IN THE DRAWINGS:

REMARKS

Present Invention

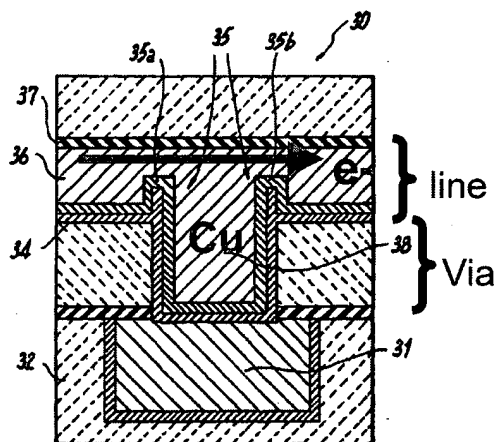
Further in the Office Action, the Examiner rejected Claims 1-6 under 35 U.S.C. §102(b) as allegedly being anticipated by Wang et al. (U.S. Patent No. 6,383,920) ("Wang").

However, the present invention enhances the electromigration resistance, i.e., slows down electromigration phenomena (see paragraph [0034] of the present specification) by extending a portion of the metal liner partially into an adjacent metal level of the first and second metal levels which structure is neither taught by nor suggested in Wang. This partial extension of the liner according to the invention forces electrons to go “around the fence” and flow down through the via that eliminating the current crowding effect and thus, less migration.

**FIG. 2
Prior Art**

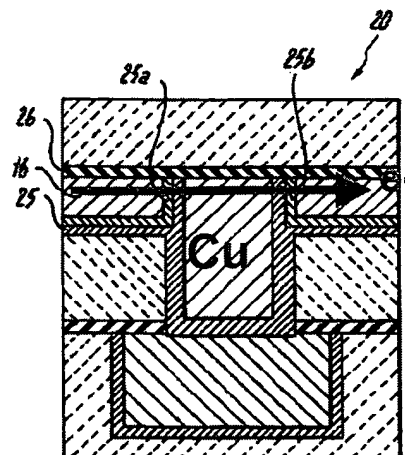
Applicants respectfully disagree. As shown illustrated below, Figure 2 of the present drawings depict the embodiment described in Wang (e.g., corresponding to Figures 2H and 2L of Wang), which clearly shows, after a second chemical mechanical polish step, the resulting structure where the liner material 25, 25a and 25b completely blocks the electro path in the line level. In the present invention shown below, and as set forth in Claims 1 and 5, only a portion of the metal liner extends partially into an adjacent metal level of the first and second metal levels. Clearly, Wang does not teach or suggest such a feature. Wang show a process for fully encapsulating a copper via in a semiconductor device as a way to prevent void formation in the bottom of the via due to electromigration.

It is additionally submitted that the method steps as depicted in Figures 10A-10H for instance are clearly distinct from the methods as described in Wang (Figures 2B-2L,) and reiterate again that the formed barrier materials in Wang that are intended to fully encapsulate a via in a semiconductor device completely blocks the electro path in the line level. The claims of the present invention require that a portion of the metal liner partially extends into an adjacent metal level of the first and second metal levels (no complete extension) and again this is neither taught nor suggested in Wang.
